**Request for Direction Report  
Zoning By-law Amendment and Subdivision  
Applications  
3083-3101 Dufferin Street and 770 Lawrence Avenue  
West**

<b>Date:</b>	November 3, 2009
<b>To:</b>	North York Community Council
<b>From:</b>	Director, Community Planning, North York District
<b>Wards:</b>	Ward 15 – Eglinton-Lawrence
<b>Reference Number:</b>	07 283458 NNY 15 OZ and 07 288511 NNY 15 SB

The purpose of this report is to seek Council's direction for staff to attend the Ontario Municipal Board in opposition to the development as currently proposed and advance the staff position as outlined in this report.

**Attachment 1: Proposed Draft Plan of Subdivision (Revised)**

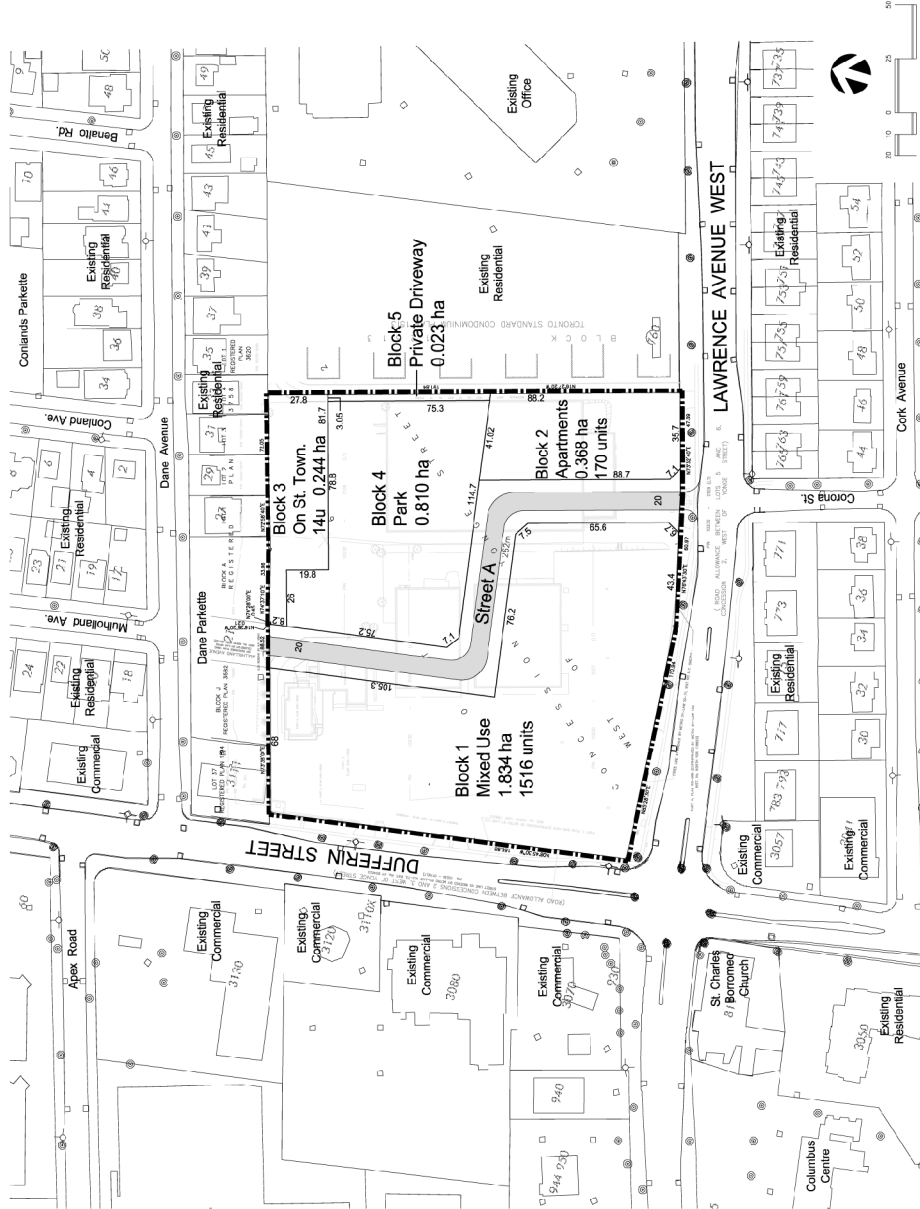
In June of 2009 the applicant submitted a revised Draft Plan of Subdivision (Attachment 1). The modifications resulted from comments provided through the Working Group process, comments received at the Community Consultation Meeting and results of City staff review. The revised plan was also influenced by the work of the Lawrence-Allen Revitalization Project. The substantive changes are as follows:

- Reconfiguration of the road in the north portion of the site;
- Reconfigured park block;
- Reduction in the number of apartment buildings and units in the eastern portion of the site;
- Reduced height of the apartment building in the eastern portion of site; and
- Introduction of townhouses in the northeast corner of the site.

The proposed 20-metre public road through the site originally connected with Dufferin Street at the northern-most point of the property in a location very close to Dane Avenue. This created an awkwardly-shaped park block abutting the existing Dane Parkette. Substantial shadows were cast over the park by the proposed buildings and the awkward shape did not facilitate programming and good park design. The park block has been redesigned into a more rectangular shape for ease of programming, to provide street edges to promote visibility, access, prominence and safety in the park and to improve access to sunlight and skyview. The proposed location provides visibility from Lawrence Avenue giving prominence to the park. The proposed park is now larger to incorporate lands equivalent to the area of Dane Parkette as well as the required parkland dedication for the proposed development and is intended as a place to be shared by existing and future residents.

In the initial plan, the easternmost development block abutting the existing Liberty Walk townhouse development was proposed to contain two apartment buildings ranging in height from 7 to 14 storeys. In the revised proposal, an 8-storey apartment building is proposed to front on Lawrence Avenue West and extend north for approximately half the depth of the site. The park block is located north of this proposed building and in the

northeast corner of the site, abutting the rear yards of detached dwellings fronting Dane Avenue, the plan proposes fourteen 4-storey townhouse units with their rear yards facing north. A shared driveway along the north property boundary would provide vehicular access to the townhouses and enable a positive front edge to the park along its north edge. The shared driveway connects the townhouses with the new public road, crossing a section of the proposed park block and potentially interrupting pedestrian flow from the larger park block north to Dane Avenue. Staff are of the opinion this shared driveway should be truncated in the form of a hammerhead so that the park block connection is not interrupted or reconfigured to connect north to intersect with Dane Avenue.

The existing Dane Parkette is 0.35 hectares (3,500m<sup>2</sup>). Adding the required parkland dedication to the Dane Parkette yields a park block requirement of 0.85 hectares (8,453m<sup>2</sup>). The park block shown on the proposed Draft Plan of Subdivision is 0.81 hectares (8,100m<sup>2</sup>) in size. The park block shortfall of 0.035 hectares (350m<sup>2</sup>) could be addressed by adding the land area proposed to be used for the townhouse shared driveway and by providing a park/walkway connection to Dane Avenue.

A land exchange involving Dane Parkette with the applicant could achieve a larger, more cohesive park to accommodate a wider range of programming possibilities. Addressing the park dedication shortfall by providing park frontage on Dane Avenue would enable direct access to the new park block for existing residents to the north and provide improved sight lines into the park. Staff are prepared to continue discussions with the applicant in this regard.

Should the land exchange with the applicant unfold as described above, it is proposed that the private driveway that provides the townhouse development with a connection to the new street be eliminated. The lane could be terminated in the form of a hammerhead at the west end of the townhouse blocks or alternatively be reconfigured to connect northward to Dane Avenue.

Attachment 2: Site Plan (Revised)

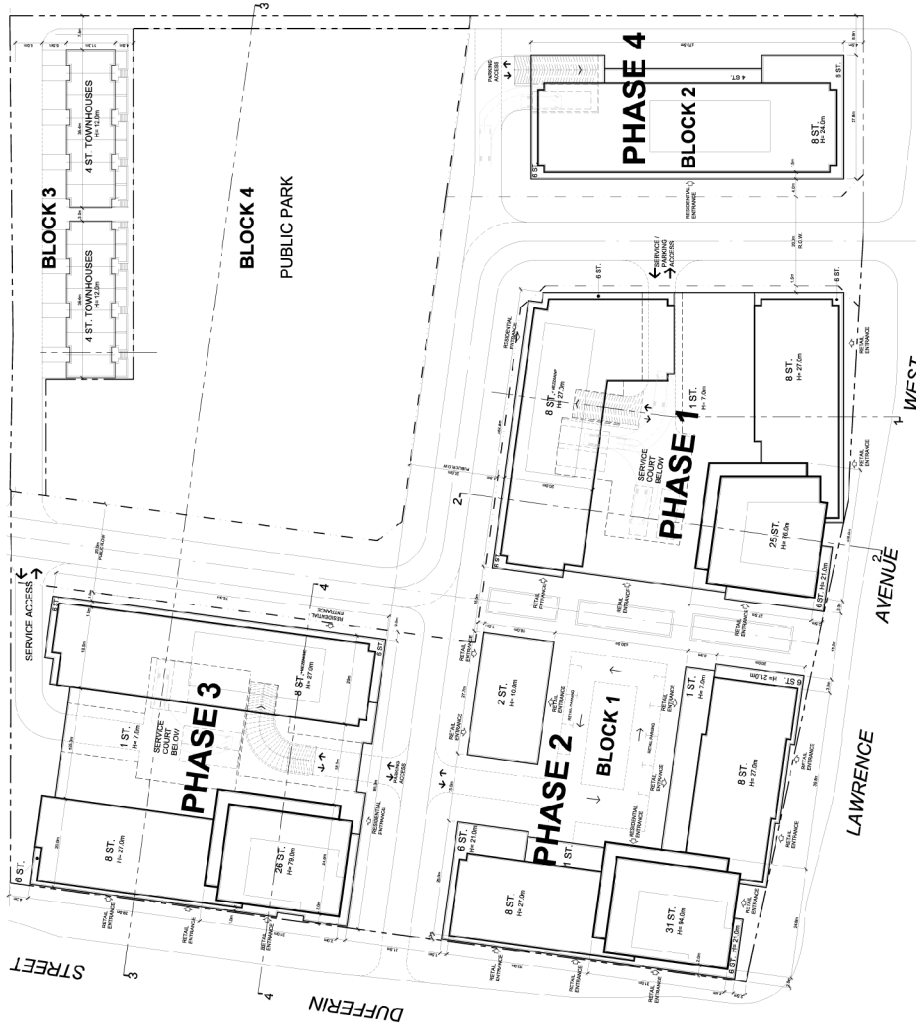
However, the proposed eastward transition is inappropriate in that an 8-storey building is proposed on Block 2, adjacent to the existing and recently constructed 3.5-storey Liberty Walk townhouse development. A shared access driveway straddles the common lot line between the proposed building on Block 2 and the townhouse development. A 6-storey component of the proposed building is located 8.9 metres from the common property line and 4.5 metres from the edge of the shared driveway. In addition to making a poor transition to the much lower townhouse development, this creates an uninviting environment for both vehicles and pedestrians utilizing the driveway in terms of sun and

wind conditions. It is recommended that the height and mass of this proposed building be reduced to 6-storeys (20m) with appropriate transition in the form of sculpting and stepdowns adjacent to the townhouse development and shared driveway. A 2-3 storey expression with grade-accessible garden apartments along the eastern lot line facing the townhouses and shared driveway would be appropriate.

The second massing transition should occur from the southern and western edges of the development site (the arterial roads) towards the interior of the site. An appropriate transition would require the proposed buildings located along the internal road to have a reduced mass relative to the buildings proposed along the arterial roads. It is recommended these internal buildings be reduced in height, with additional sculpting and stepdowns, to provide an appropriate scale of building wall adjacent to the internal road and to provide appropriate sunlight and skyview to the sidewalks on the internal road. An outcome of this will be enhanced sunlight conditions on the park and more comfortable wind conditions, particularly during the winter months.

**Attachment 3a: South Elevation (Lawrence Avenue West)**

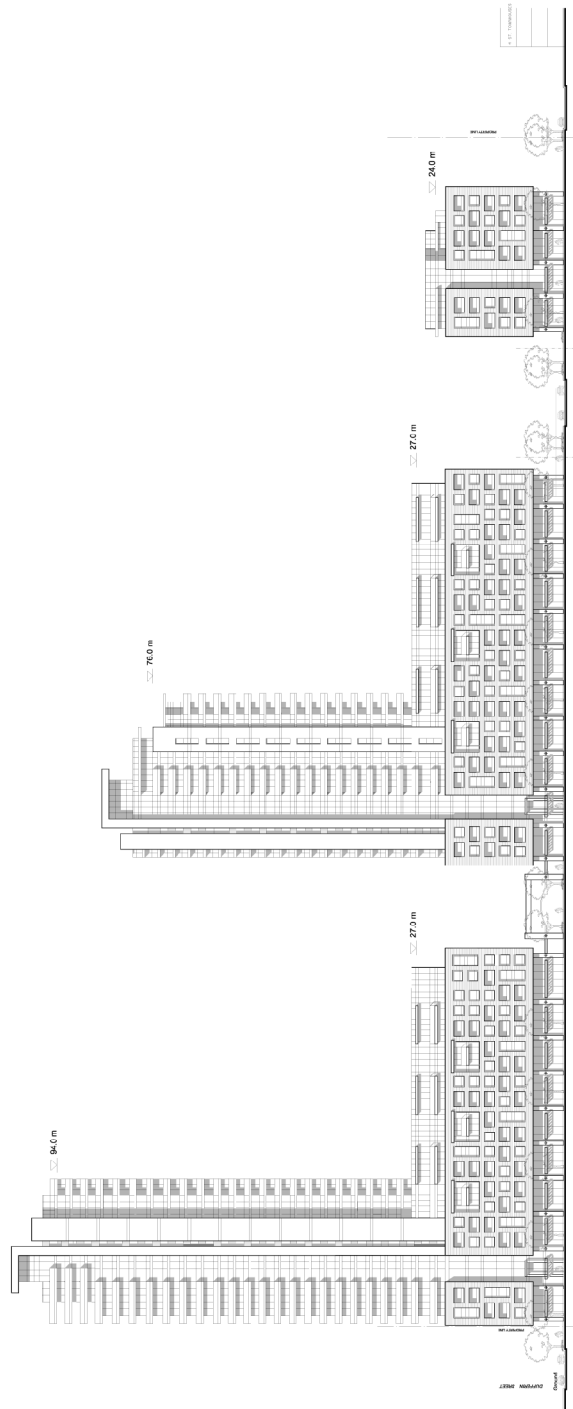
The applicant is proposing three towers along Dufferin Street and Lawrence Avenue West which exceed this height limit. The tower at the corner of Dufferin Street and Lawrence Avenue West is proposed to be 31 storeys and 94 metres in height. The tower to the north fronting Dufferin Street is proposed to be 26 storeys and 79 metres high while the tower to the east along Lawrence Avenue West is proposed to be 25 storeys and 76 metres high. These proposed heights are exclusive of roof top mechanical areas which are included in the airport height restrictions.

The area surrounding the Lawrence Avenue West and Dufferin Street intersection is not a tall building district, particularly given the restrictions imposed by the nearby Downsview Airport operation. Staff are of the opinion the proposed tower heights should approximate the existing and planned context along the corresponding arterial road, in this case, being the equivalent of 12 residential storeys along Lawrence Avenue. The existing context for building height along Dufferin Street is 16 storeys which should be reflected in the proposal.
